VOLUME III - PRELIMINARY
FINAL ENVIRONMENTAL IMPACT STATEMENT
CONSTRUCTION AND OPERATION OF
SPACE LAUNCH COMPLEX 7

VANDENBERG AIR FORCE BASE, CALIFORNIA
23 OCTOBER 1989

SUBJECT: *Transmittal Preliminary Final Environmental Impact Statement Space Launch Complex 7
Vandenberg Air Force Base, California*

FIGURE 2.1.11

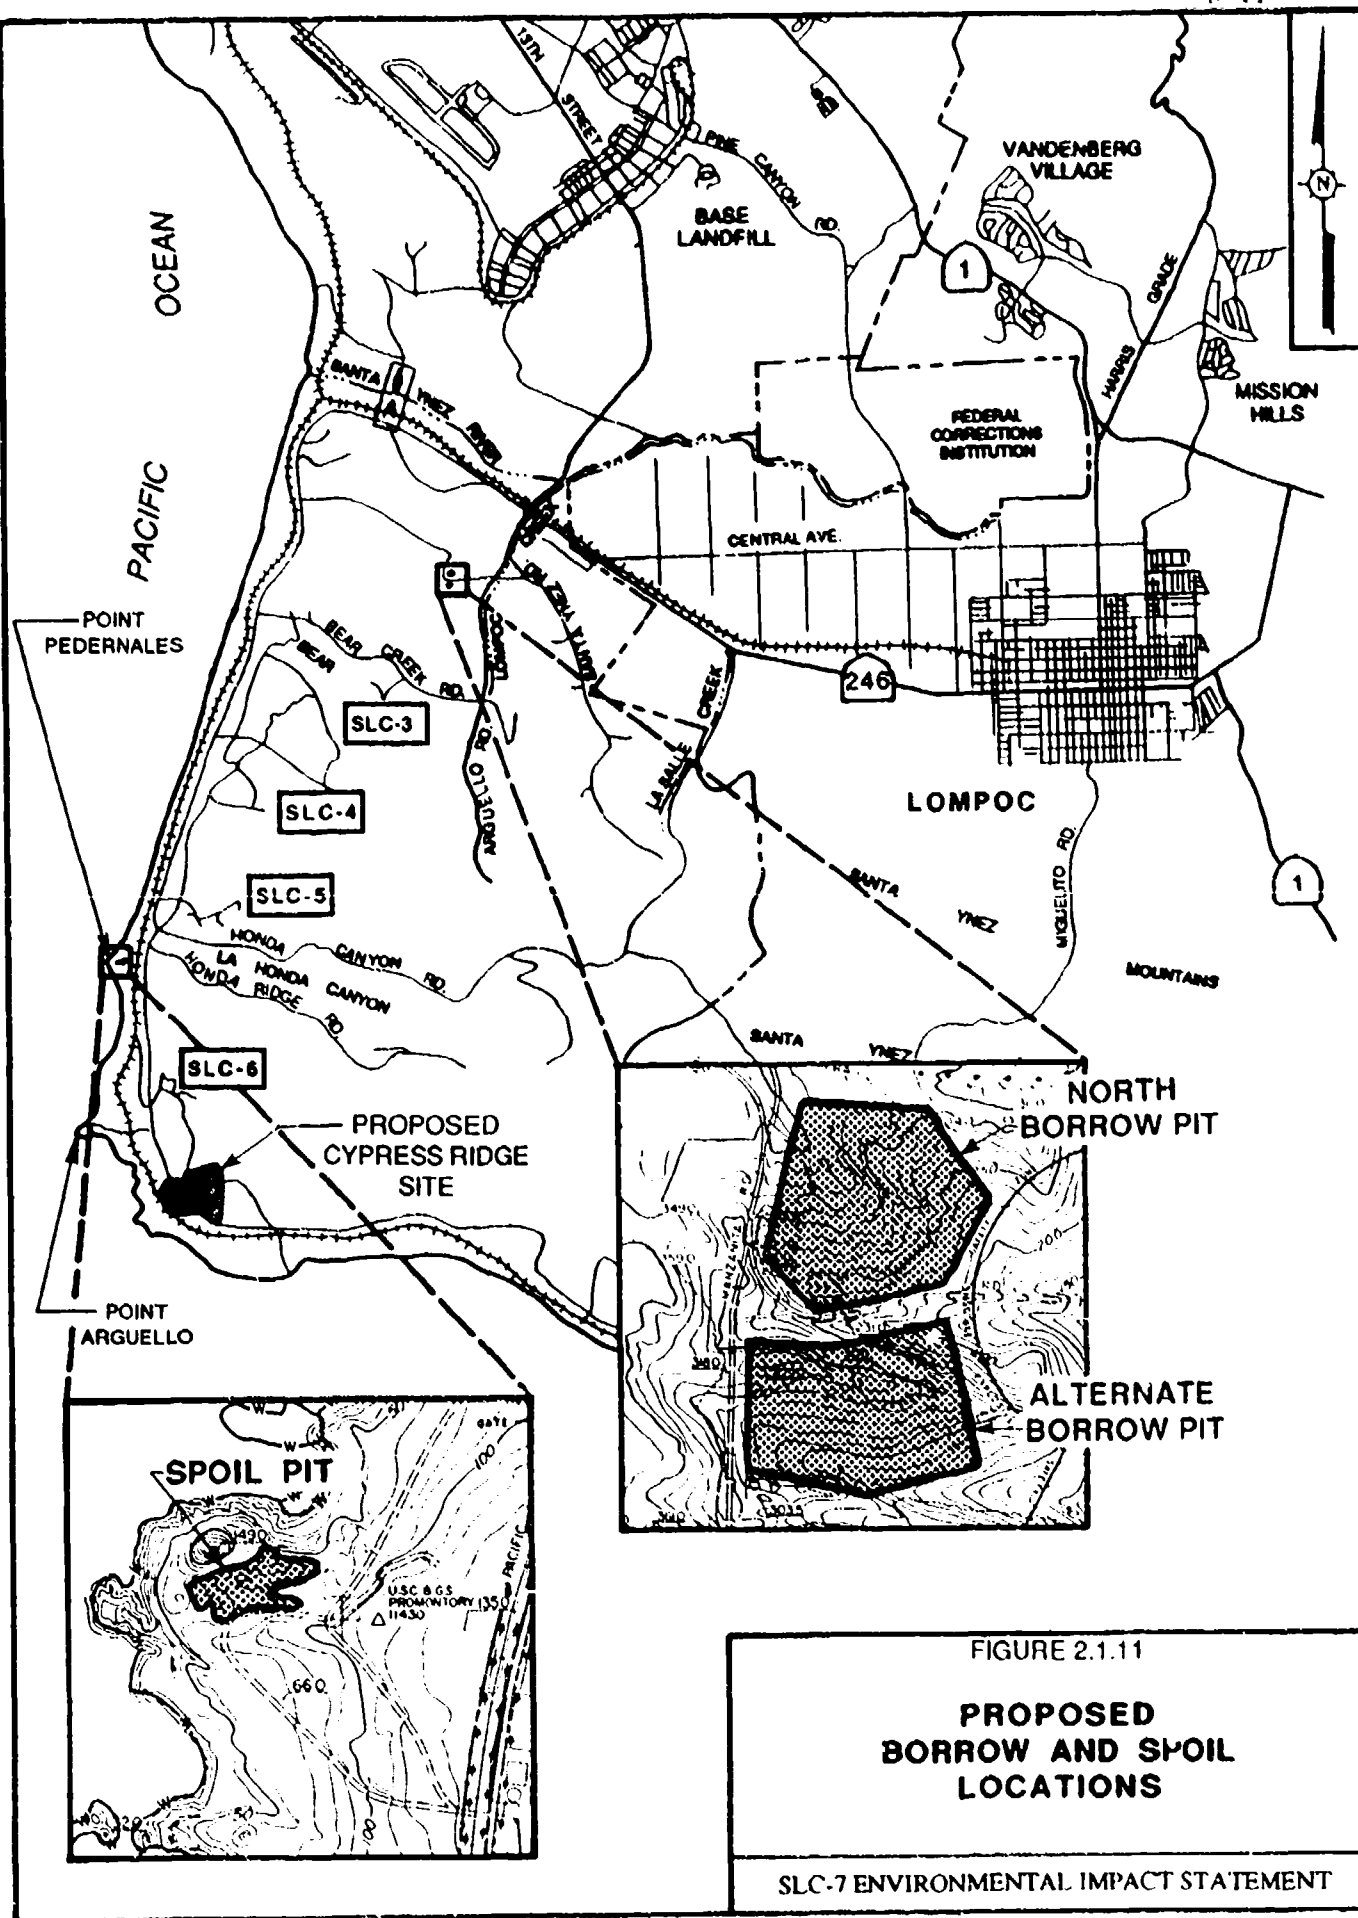
[44] Page 2-25 - More information is needed on the locations of the proposed borrow and spoil pits indicated in Figure 2.1.11. Borrow areas adjacent to the Santa Ynez River may contain riparian/wetland resources which could be impacted by borrow activity. This needs clarification.

The potential borrow pits adjacent to the Santa Ynez River are no longer being considered as areas that would be utilized as a source of material for the construction of SLC-7. Changes to Figure 2.1.11 are noted in Section 3.0 of this Final EIS.

Section 2.1.4.1, page 2-25, Drawing changed for Figure 2.1.11.
